8648A-02B

S E R V I C E N O T E

8648A Synthesized Signal Generator

Procedure to replace defective 864X display module

FIGURE 1

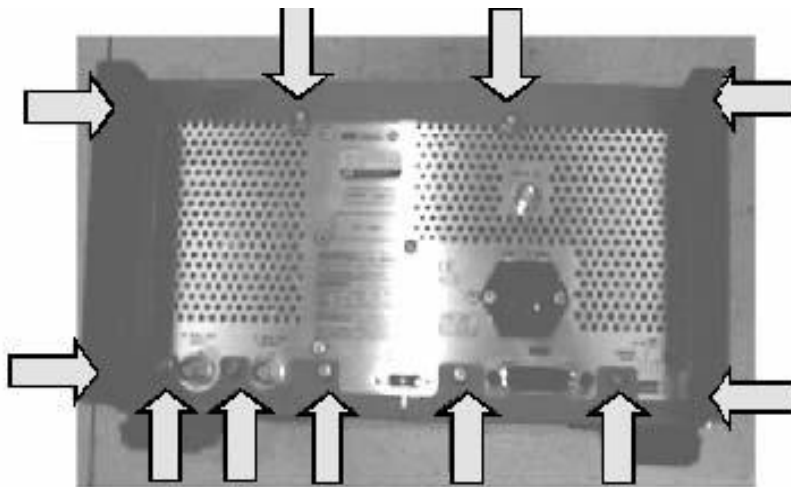
Step 1. Remove the 11 outer casing screws (MP14) from the instrument cover (MP8) with a Proto T15 torx driver.

FIGURE 2

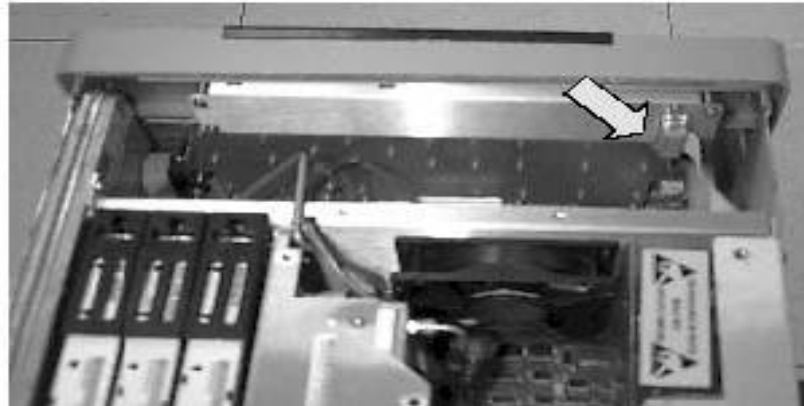
Step 3. Remove the display D-type connector (W2).

FIGURE 3

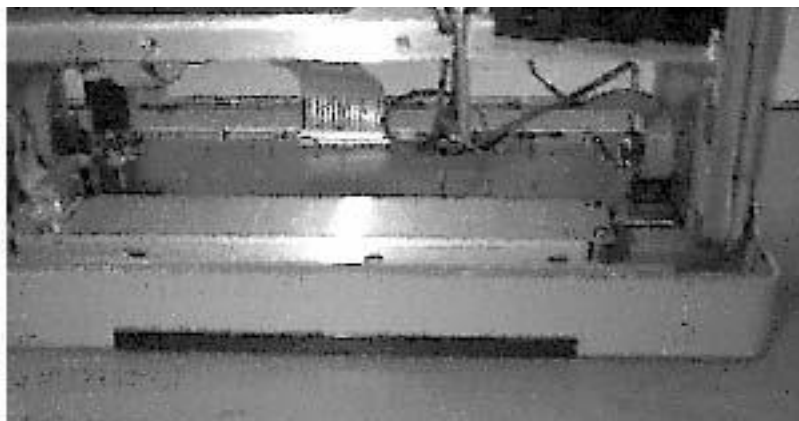
Step 4. Place the unit (front panel) face down on a protected work surface area.

FIGURE 4

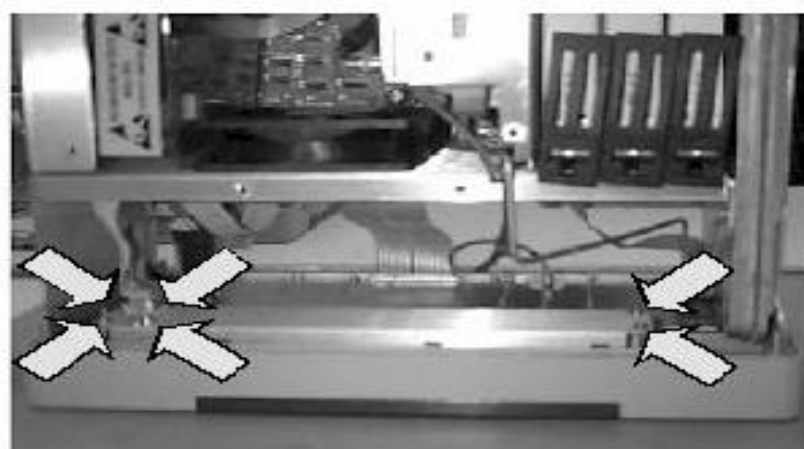
Step 5. Remove the 6 screws (MP12) from the display cover (A1MP4) with an L-shaped T10 torx driver.

FIGURE 5

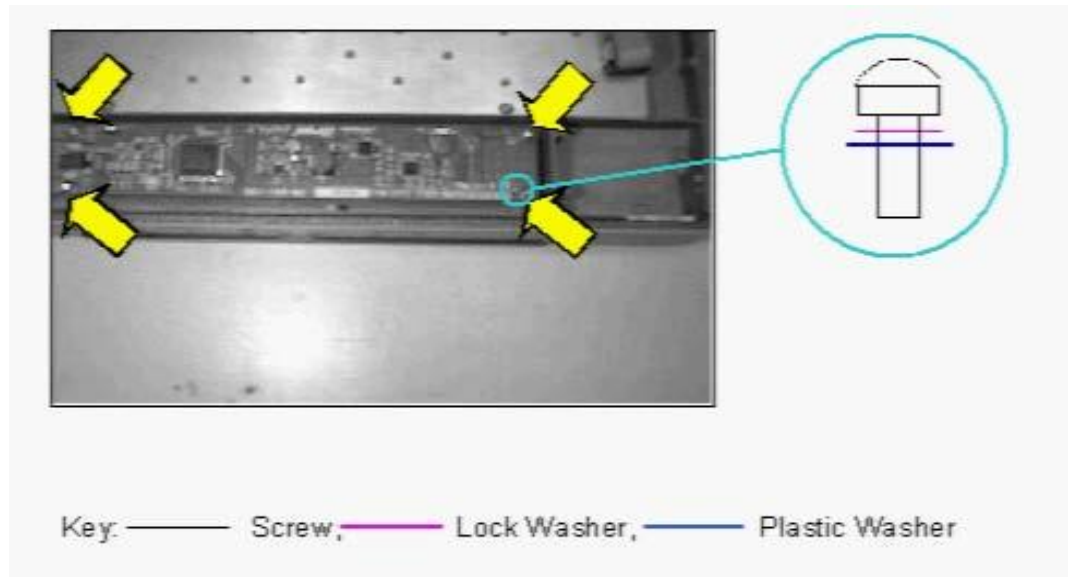
Step 7. Remove the 6 screws (MP12) from the display VFD 2x40 (A1A4) with an L-shaped T10 torx driver.

FIGURE 6

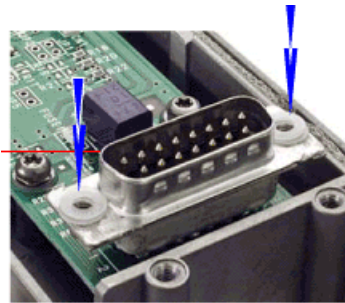
Step 10. Stack white washer 3050-0300 (2X) and place over threaded insert on D-type connector of 08648-60035

FIGURE 7

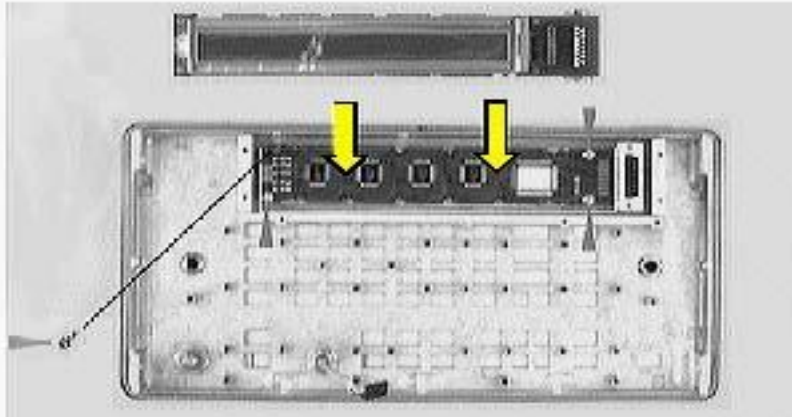
Step 11. Fit the replacement display, with plastic lens cover removed, by pushing toward the bottom of the front panel display aperture.

FIGURE 8

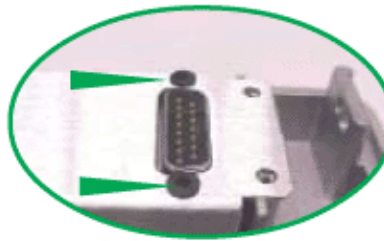
Step 12. Attach gray bushing 0340-1162 (2X) onto the display cover (A1MP4).
